SUBJECT: (7.1) Late Item – Union Street McMahons Point – Proposed Speed Cushions – Road Safety Audit Report

**ROAD SAFETY AUDIT
STAGE 2 PRELIMINARY DESIGN STAGE
AND
REVIEW OF EXISTING ROAD AND TRAFFIC CONDITIONS**

Audit Reference: 19153 RSA Stage 2

Report Issue Date: 23 January, 2020

FIGURE 2
 ROAD SAFETY AUDIT
 UNION STREET, MCMAHONS POINT
CRASH DIAGRAM

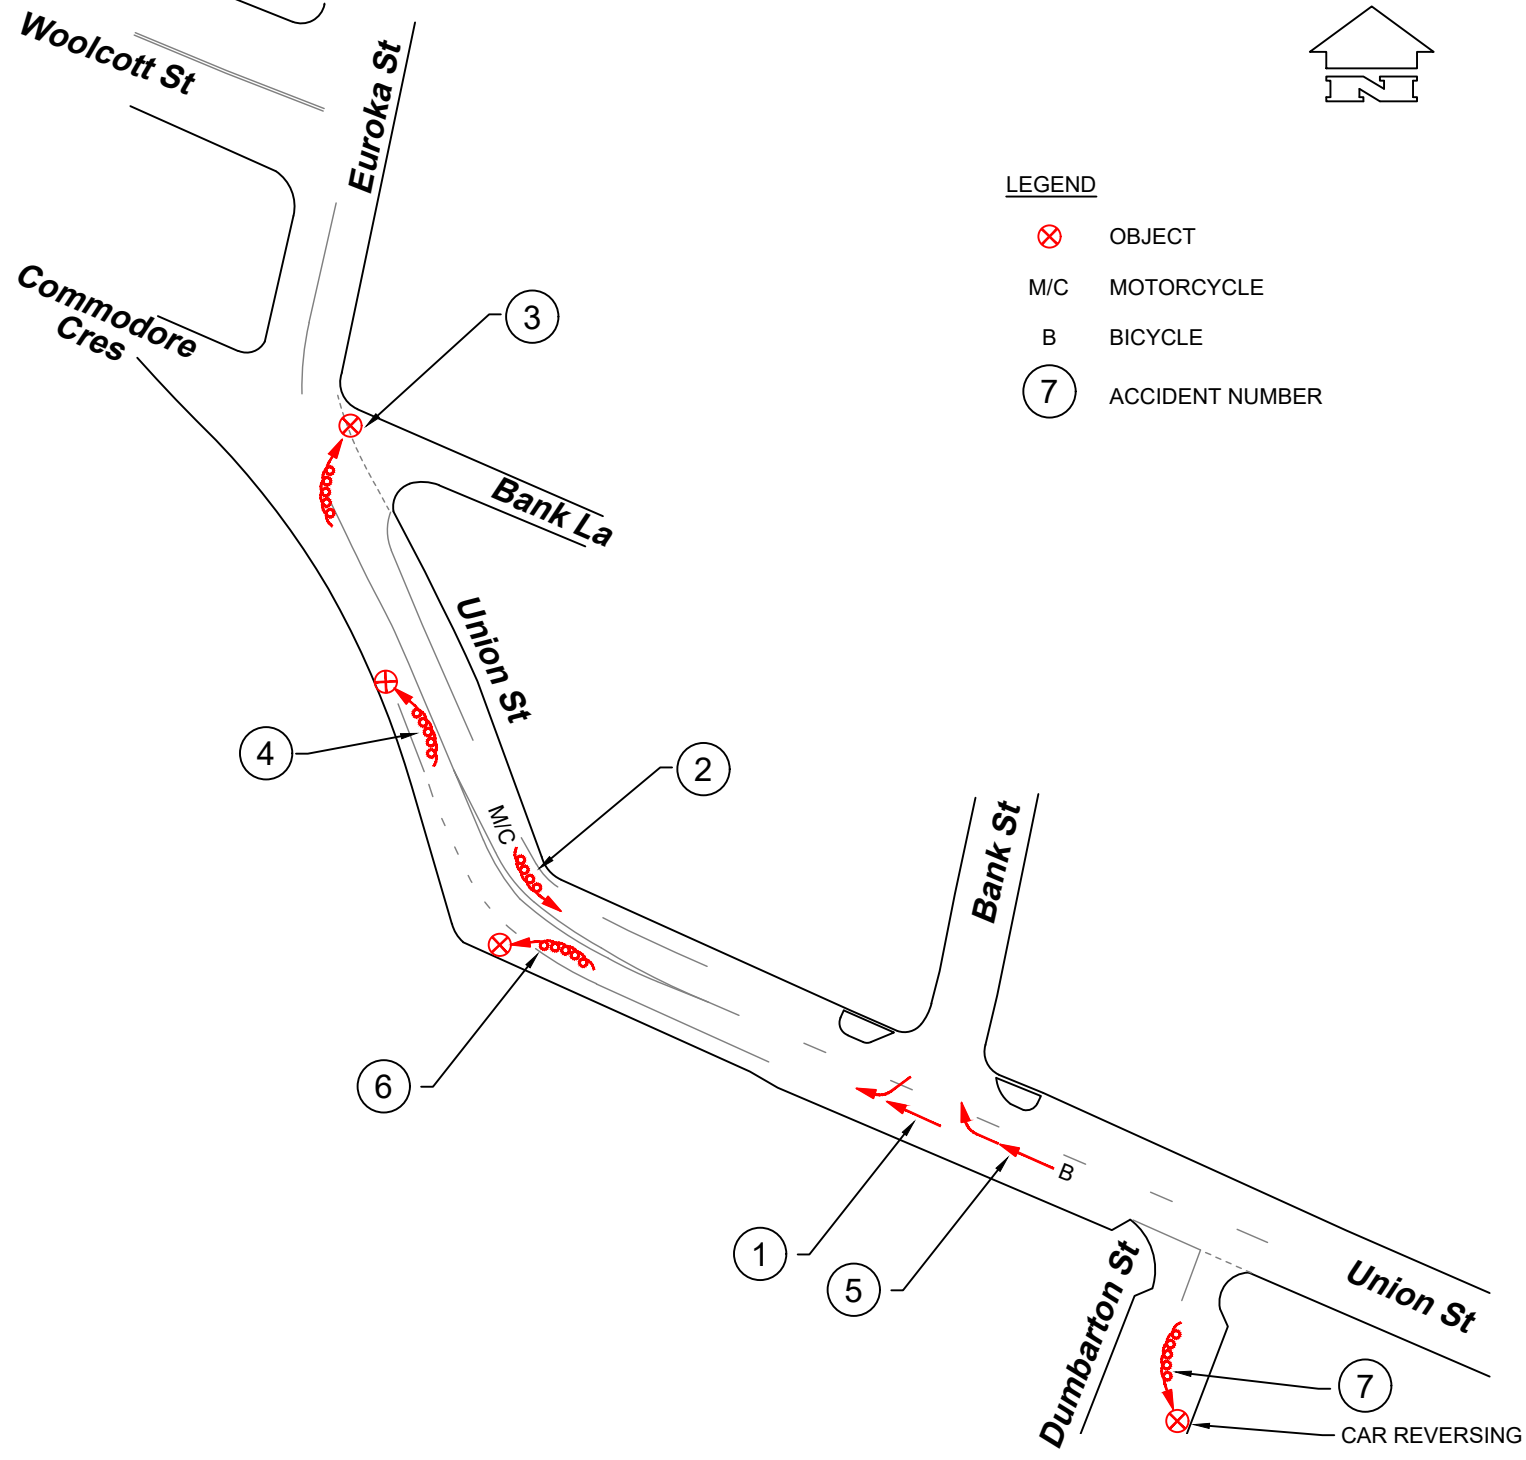
Two (2) crashes were intersection type accidents which occurred in Union Street at Bank Street. There were four (4) run off the road type crashes that occurred at or between the bends in Union Street. Three (3) of these were injury (casualty) crashes.

Adverse crossfall was noted on the bend north-west of Bank Street during site inspection. With the installation of road cushions on this bend, there is a potential risk for vehicles heading north-west not slowing down to less than 20km/h for run-off accidents due to the combination of steep grade on approach, adverse crossfall on the bend, the change in alignment, together with the road cushions.
